**Re: Docket No. 40-8903  
License No. SUA-1471  
Request for Change in Ground-water Restoration Plan**

**EVALUATION OF INJECTION OF REVERSE OSMOSIS PRODUCT WATER**

**HYDRO-ENGINEERING, L.L.C.  
JANUARY, 1998**

FIGURE 1. LOCATION OF COLLECTION WELLS FOR INPUT TO THE R.O.

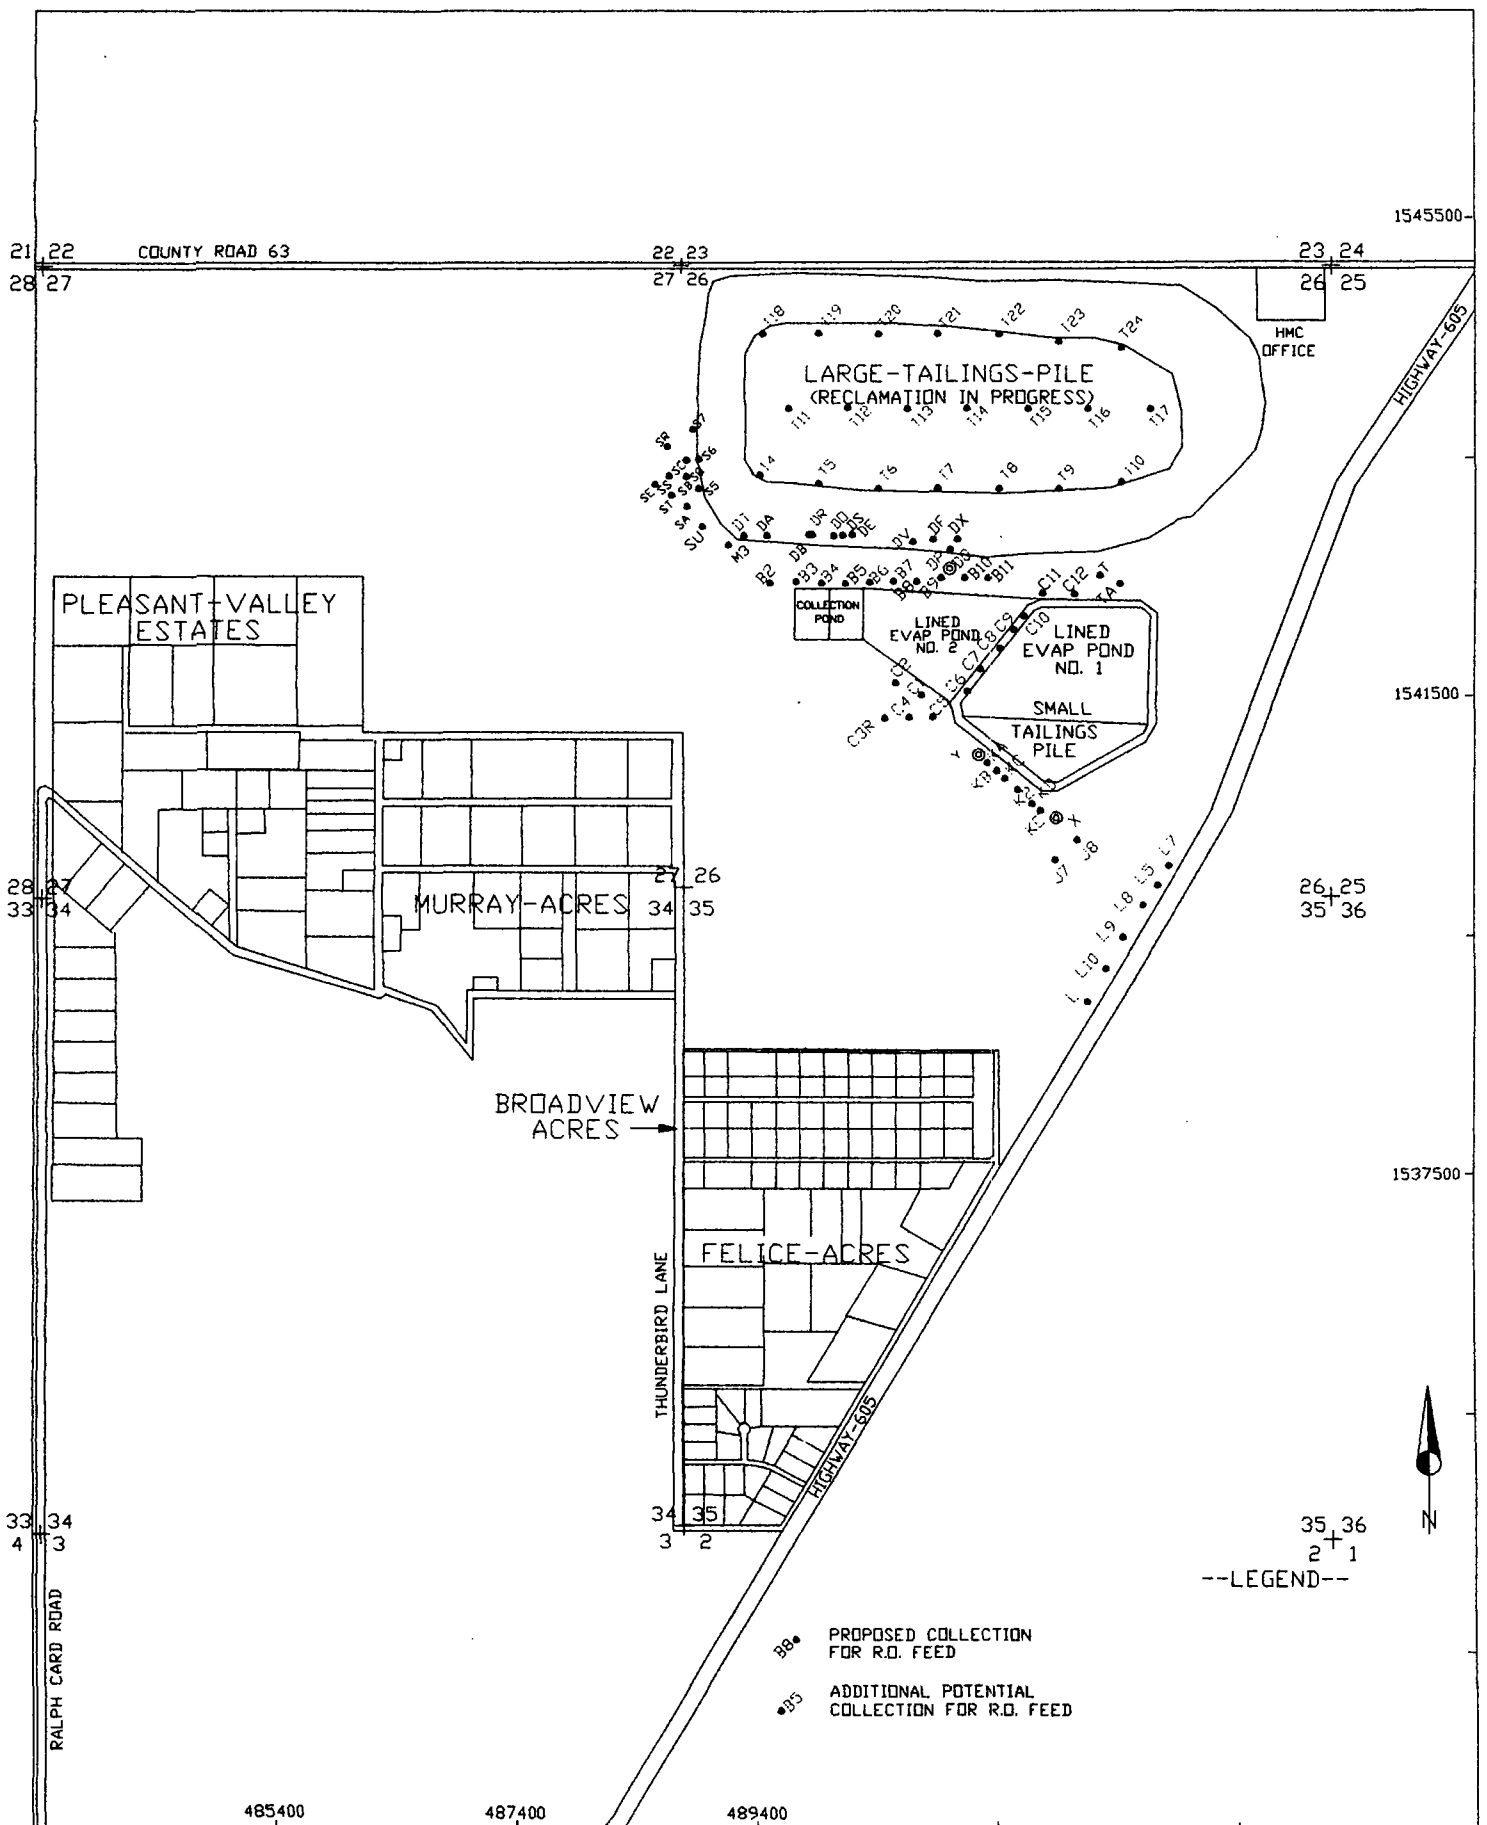
A production of up to 800 gpm is proposed from the alluvial collection wells, the tailings dewatering wells and toe drains as an input to a line softening and a low pressure RO unit. A high pressure RO unit is proposed to treat the brine discharge from the low pressure RO at a rate up to 200 gpm. These units are expected to produce up to 600 gpm of RO product and up to 200 gpm of brine. Figure 1 shows the location of the collection wells which are proposed to initially supply the RO input water. This figure also shows other potential collection wells that will likely be added in the future to supply the needed input to the RO. The particular wells that supply the RO will vary with time. For example, a series of B collection wells will be added in the next few years, while wells near the large tailings will likely be used toward the end of the project. Other wells not shown may also be used to feed the RO due to adjustments in the future in the collection system. Some collection for direct re-injection will likely continue during the RO use period.

FIGURE 3. RO INPUT AND OUTPUT SCHEMATIC

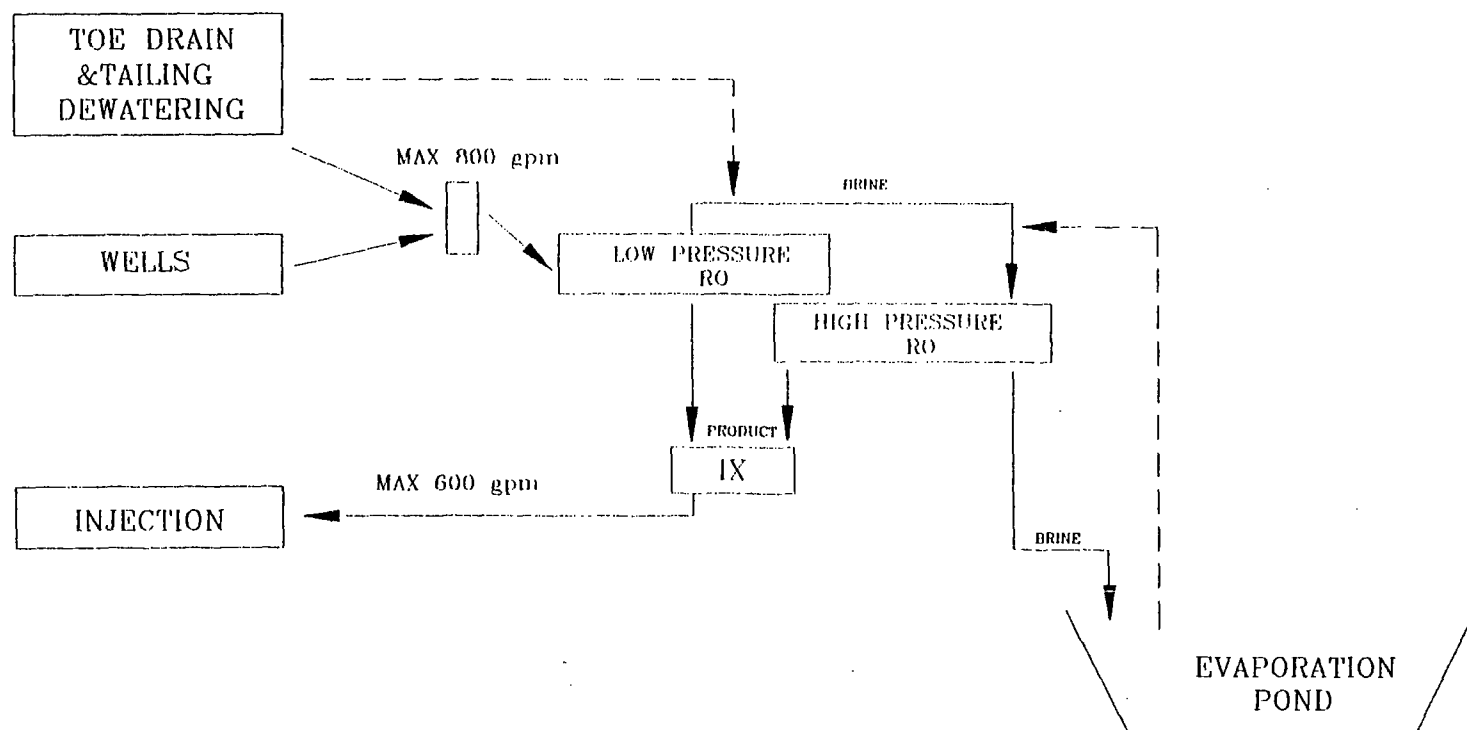
Figure 3 presents a schematic of the RO with input from the well and tailings systems and discharge of brine to the high pressure RO. Up to 800 gpm is proposed to be put through a low-pressure and high-pressure RO systems producing up to 600 gpm of RO product water for injection. The brine from the low-pressure RO would be the input to a high pressure RO which should produce equal amounts of RO product for injection and brine for discharge to the evaporation ponds. A dashed line indicates that the toe drains and tailings dewatering could be pumped to the high-pressure RO unit. Also, water from the evaporation ponds could be pumped to supply the high-pressure RO.

FIGURE 4. BACKGROUND GROUND-WATER QUALITY

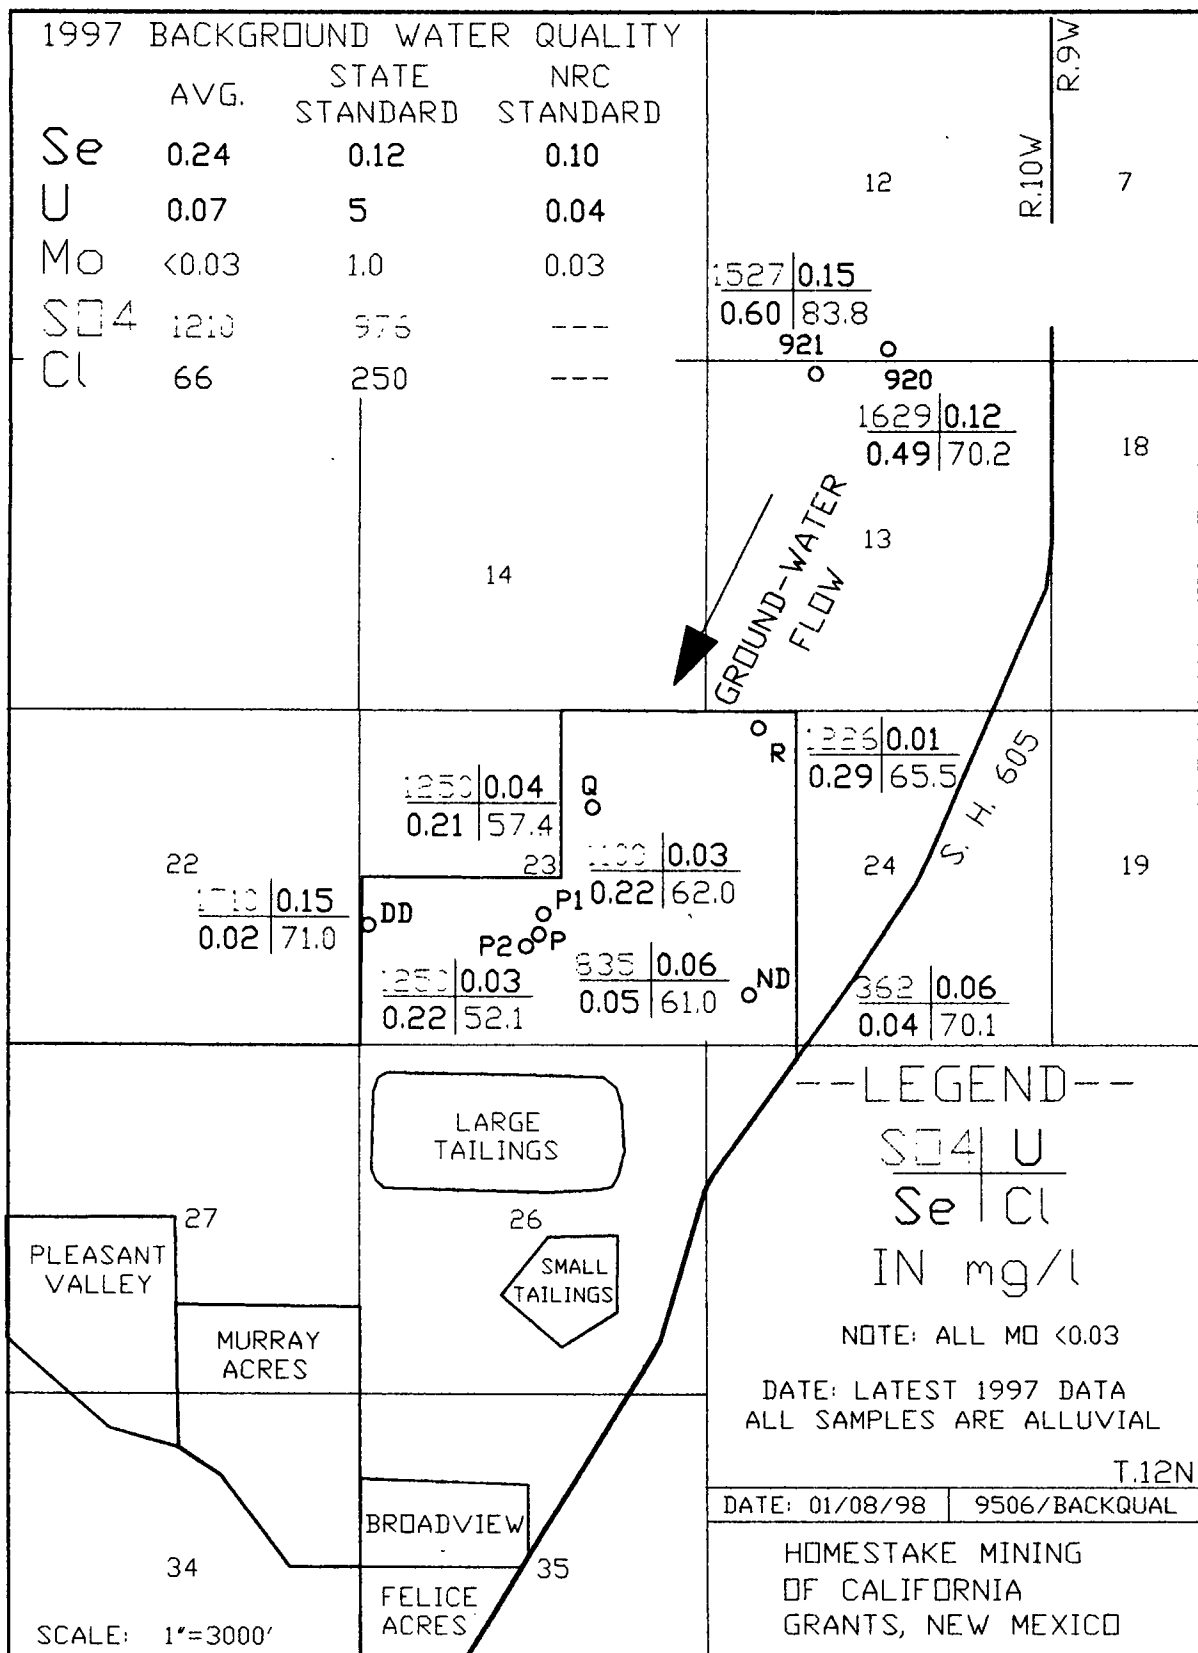
Figure 4 presents the latest 1997 water-quality data for the background wells<sup>1</sup> for four parameters, sulfate, uranium, selenium and chloride. All molybdenum concentrations in these upgradient wells are less than 0.03 mg/l. The sulfate concentrations for these wells upgradient of the large tailings vary from 362 to 1710 mg/l and averaged 1210 in 1997. Uranium concentrations also vary over a large range, from less than 0.01 to 0.15 mg/l with an average of 0.07 mg/l. Three natural uranium concentrations are nearly four times the NRC site standard of 0.04 mg/l. Selenium concentrations vary over an even

The range in concentrations in the upgradient wells during 1997 was such that water in all of these background wells<sup>1</sup> exceeded the site standards for selenium or uranium. These site standards were set based on three data points<sup>2</sup> from December 1988, January 1989 and February 1989 from only upgradient well P. The natural areal variability in the background water quality is large. Therefore, several wells and the long historical data base must be used to adequately define background concentrations. A good example of naturally occurring background variations is demonstrated by the uranium concentrations, where concentrations in the Fall of 1997 varied from 0.001 to 0.15 mg/l (see red values on Figure 4). The higher values are nearly four times the site standard of 0.04 mg/l.

FIGURE 5. PERMIT GROUND-WATER MONITORING FREQUENCY

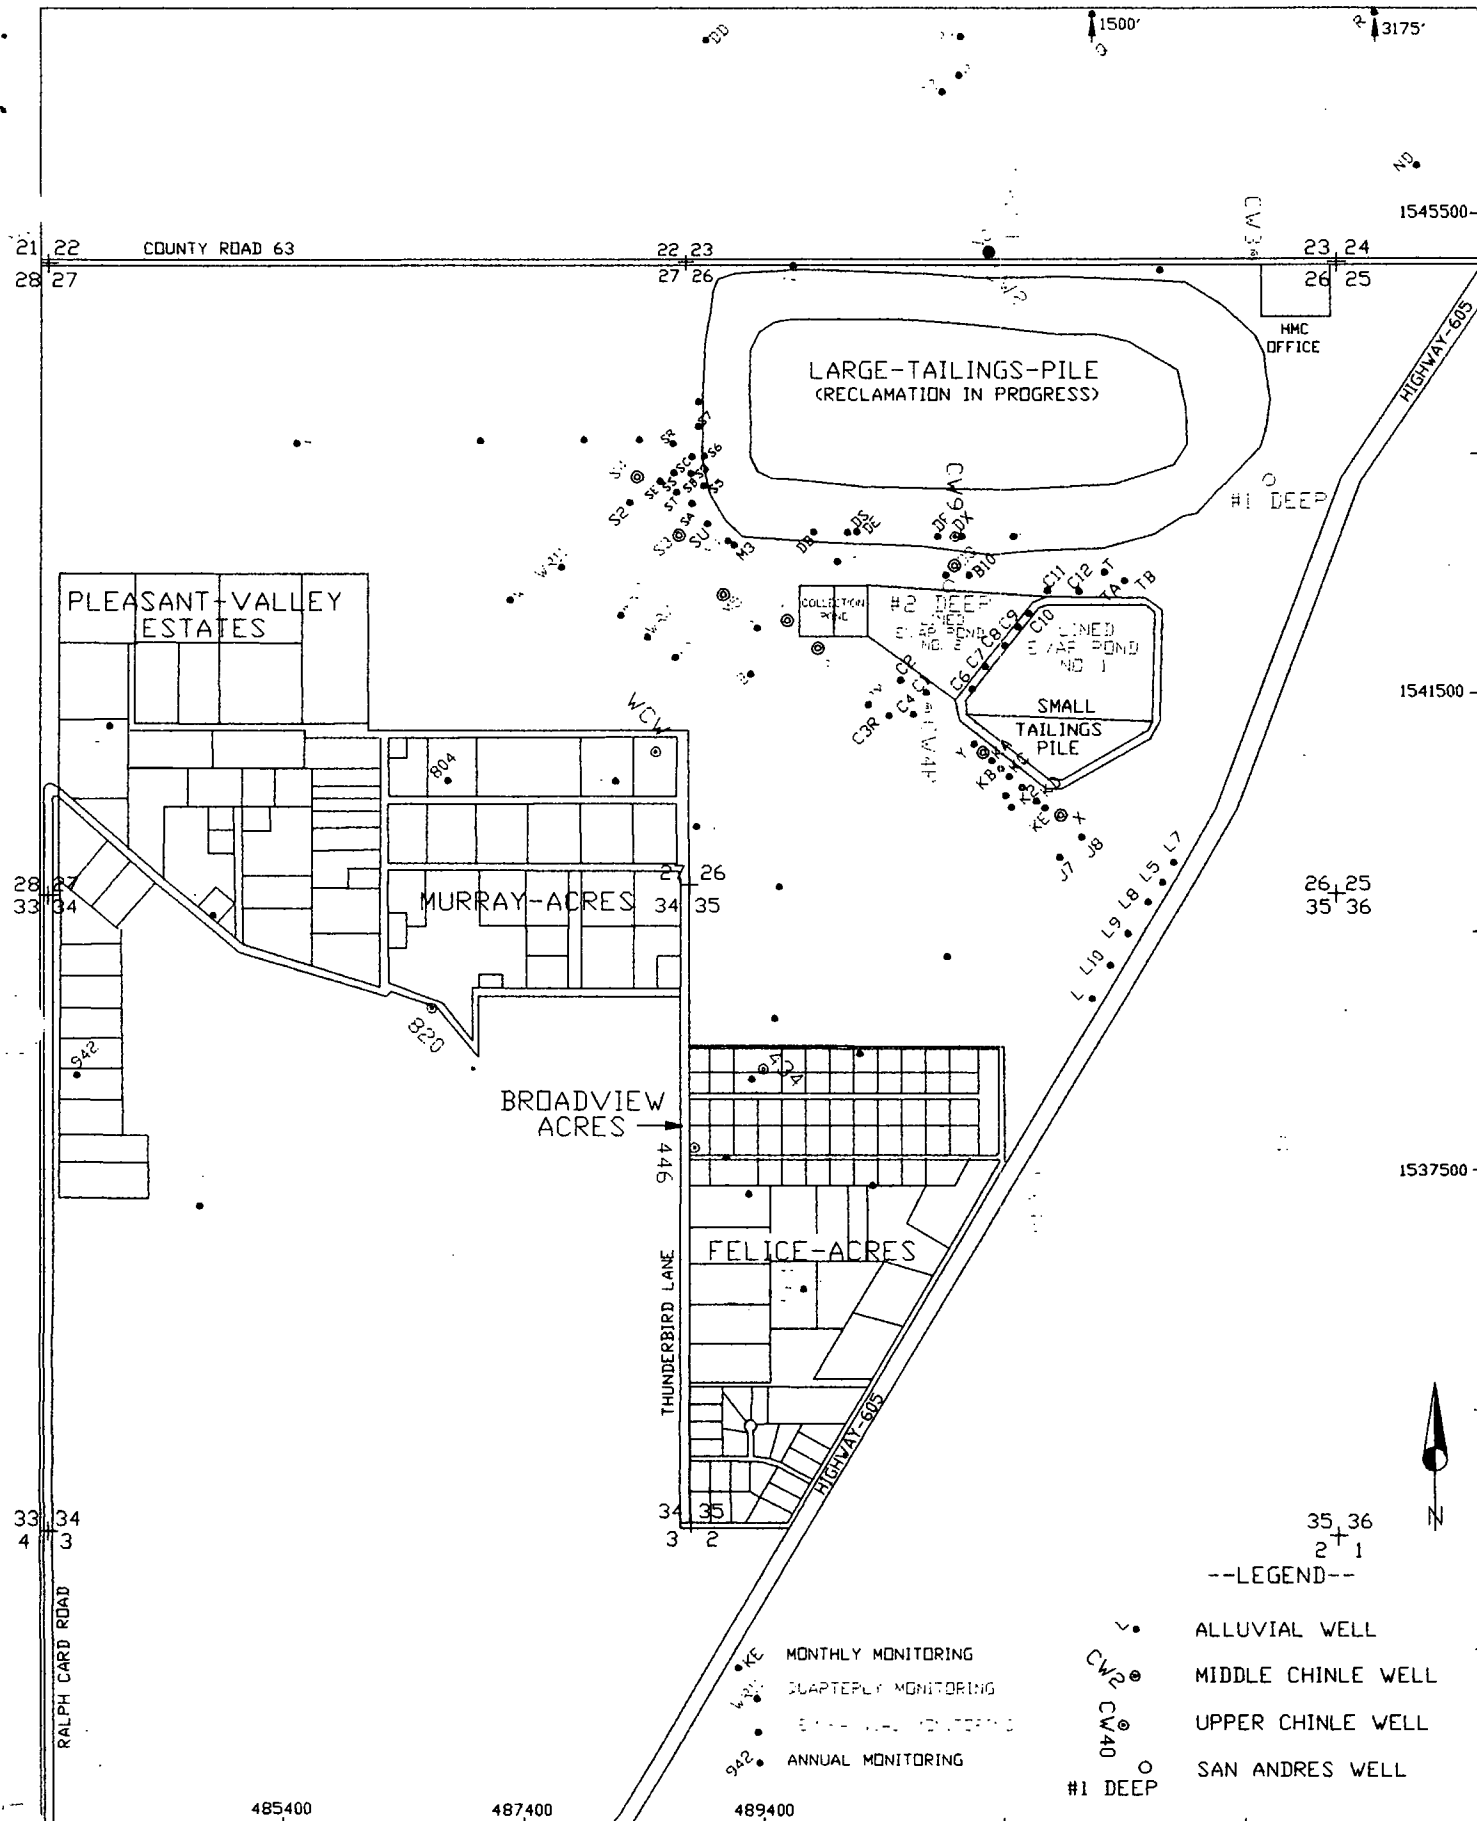
The existing ground-water monitoring program (Table 2, 08/97) for the NRC and the ED is adequate to define any changes due to the use of RO product water for injection. Figure 5 shows the location and frequency of the present monitoring system. The color

Composite samples of the RO feed and product water after the IX polishing will be monitored monthly for TDS, SO<sub>4</sub>, U, Se, Mo and Ra-226 for the first year of operation. A D list of parameters (see Table 2 of NRC or ED permits for parameter list) will be measured annually for the RO product to match the water quality monitoring for the fresh-water injection. The monthly monitoring will be switched to quarterly monitoring after one year if product water quality has been acceptable for the initial year.
